Panel Report

Yarra Planning Scheme Amendment C191

Swan Street Activity Centre

15 October 2020

Figure 2 Comparison of perspectives from two different vantage point angles

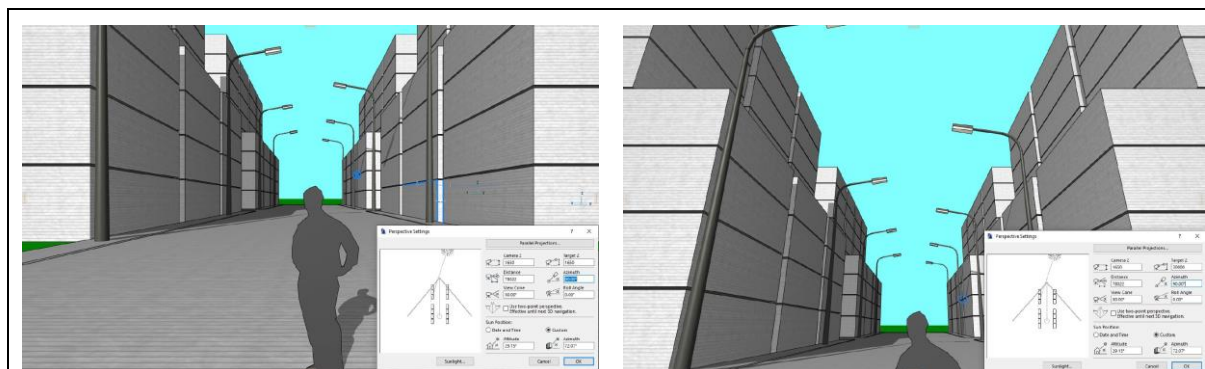
Swan Street Sales submitted that Ms Hodyl's work sought to illustrate, influence and persuade the Panel about the appropriateness of her recommended built form outcomes through inappropriate and distorted perspectives. It presented two different perspectives to illustrate distortion. These are replicated in Figure 2.

Figure 7 Original Corner Hotel building in its c1869 form

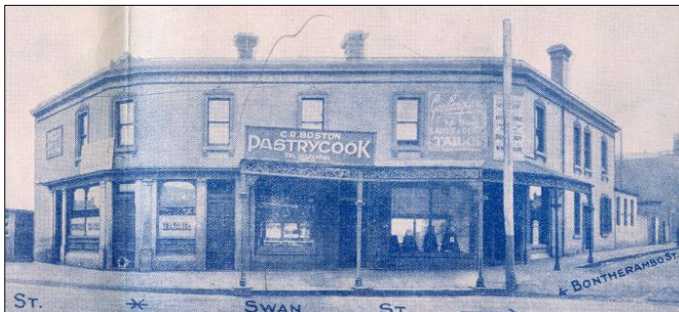
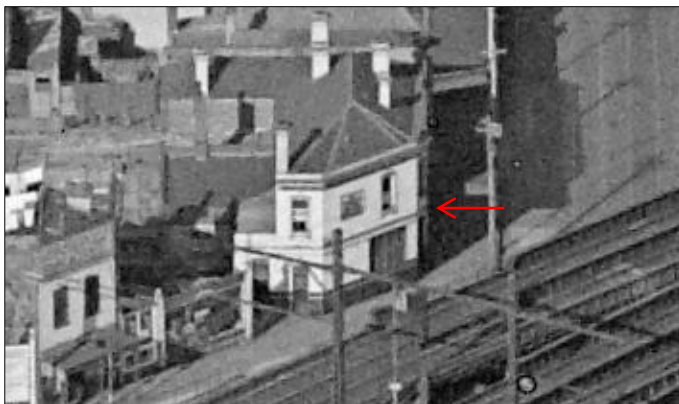
Mr Raworth included images of the original hotel building, as shown in Figure 7 and Figure 8 of this report, before it was demolished in 1955 to make way for the current building. He disputed claims in the Heritage Review and by Mr Gard’ner that the building was constructed in the mid-1960s.

Figure 10 Precinct 1 exhibited and resolved building heights and street wall interfaces

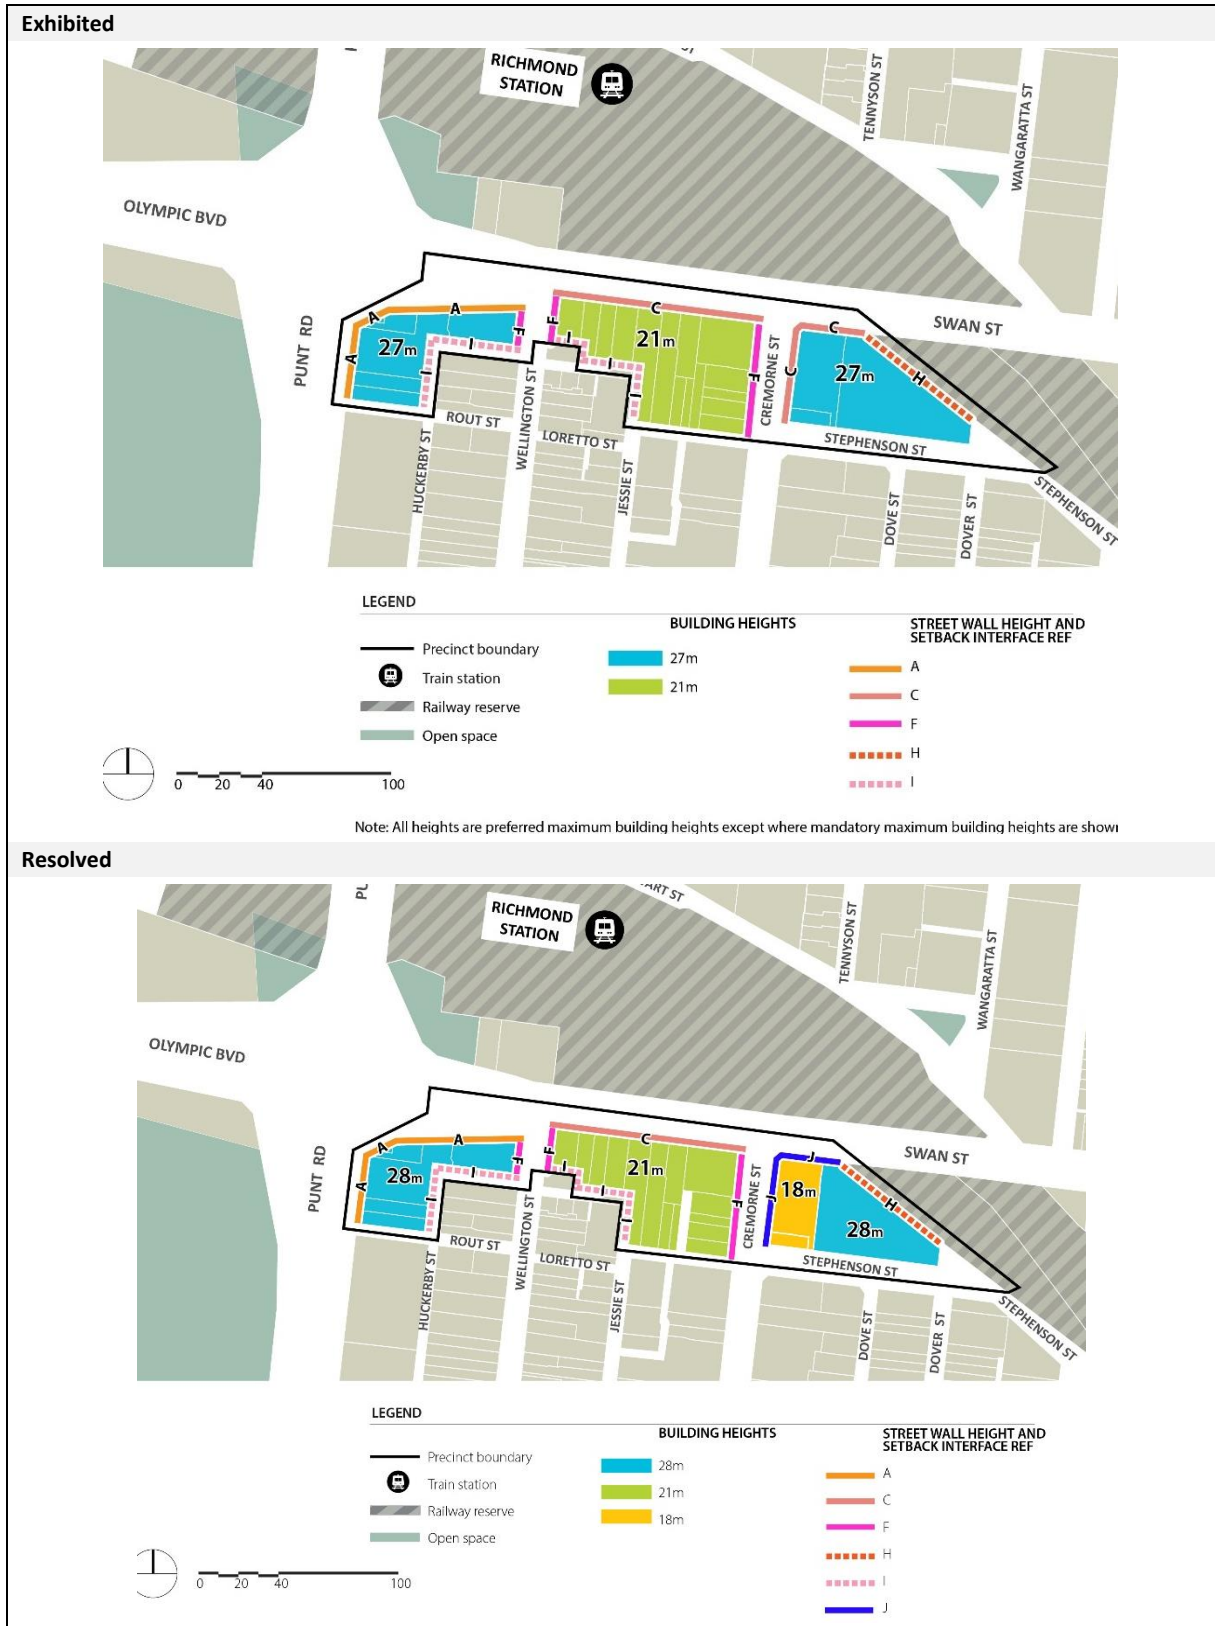
An additional provision should be added to the building height requirements for Precinct 1 to require upper levels in the Heritage Overlay that exceed the preferred maximum building height should have increased setbacks.

Figure 11 Precinct 1 exhibited and resolved building heights and street wall interfaces

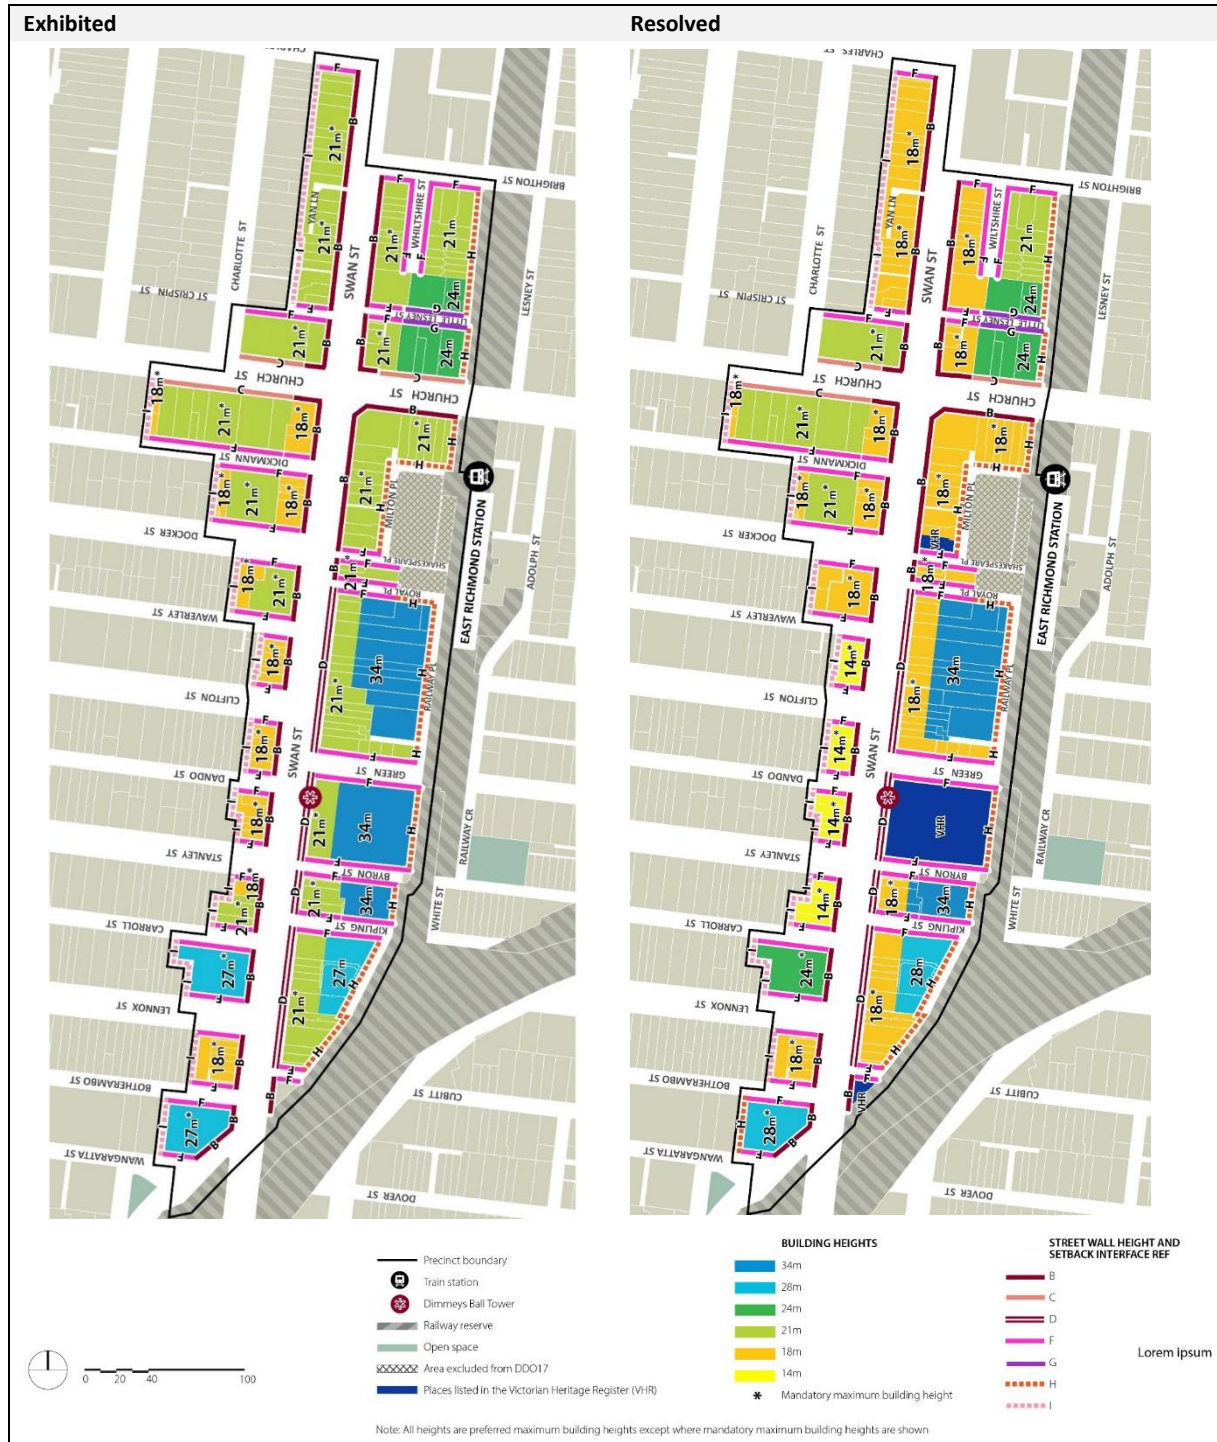
- a) apply the building heights shown in the resolved version in Figure 11 of this report except for 57-61 and 187-189 Swan Street, land bounded by Little Lesney, Whiltshire and Brighton Streets, and 421-423 Church Street**
- b) apply a discretionary maximum building height of 28 metres to the part of 57-61 Swan Street currently being used as a car park**
- c) apply a discretionary maximum building height of 28 metres to land bounded by Little Lesney, Whiltshire and Brighton Streets**
- d) apply a mandatory maximum building height of 18 metres to 187-189 Swan Street and 421-423 Church Street.**

Figure 1 to schedule 25 – Residential – Interface with an existing laneway

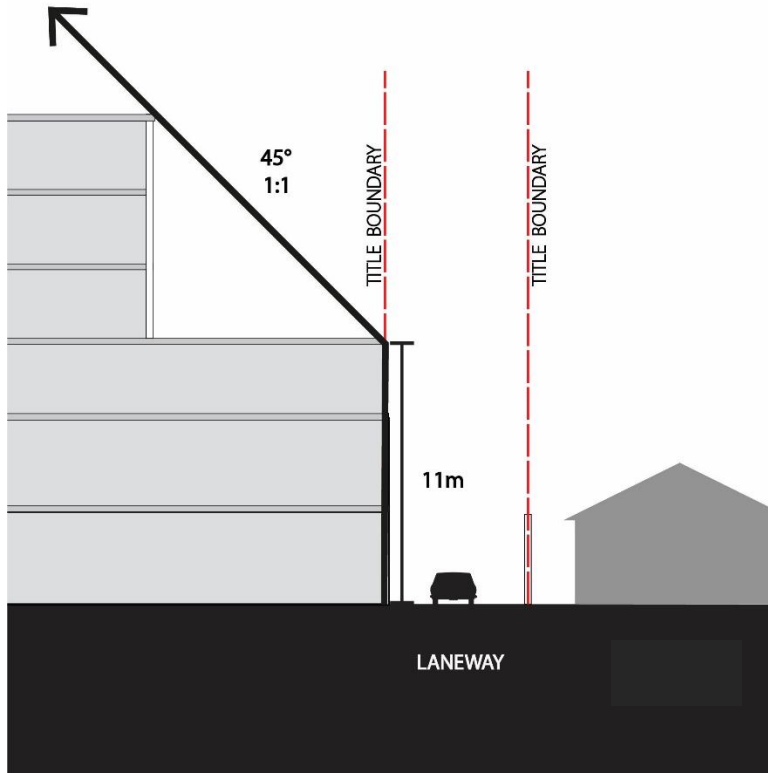
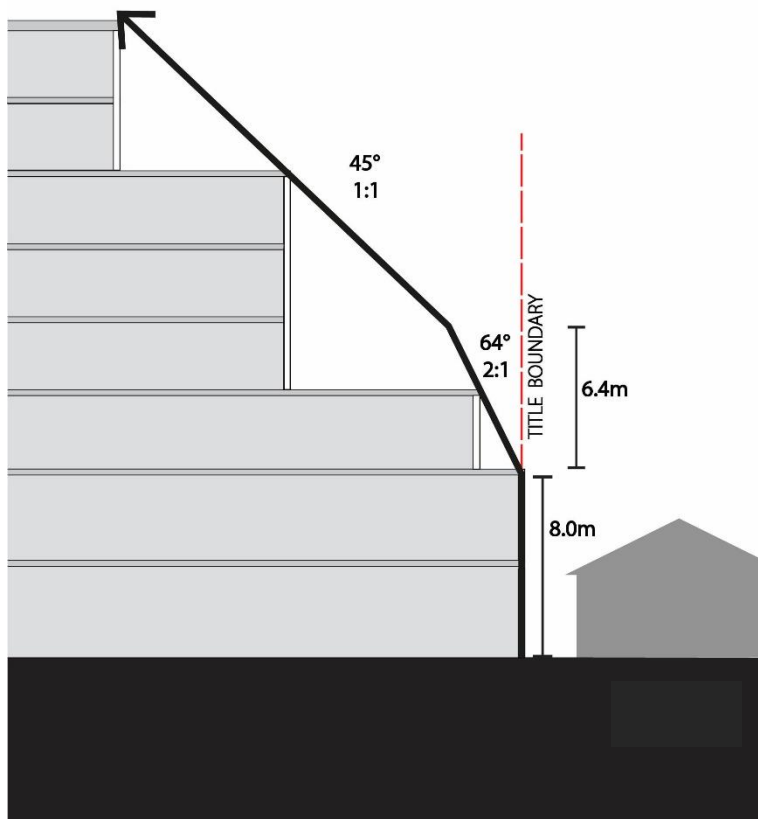
- replace the Figures 1 and 2 ‘residential interface’ terminology with ‘Interface with an existing laneway’ in Figure 1 and ‘Interface direct abuttal’ in Figure 2

- delete ‘existing residential’ in the Figure 1 and 2 cross-sections
- not include text under ‘Building heights requirements’ noting the preferred height may not be exceeded on every site because it is unnecessary
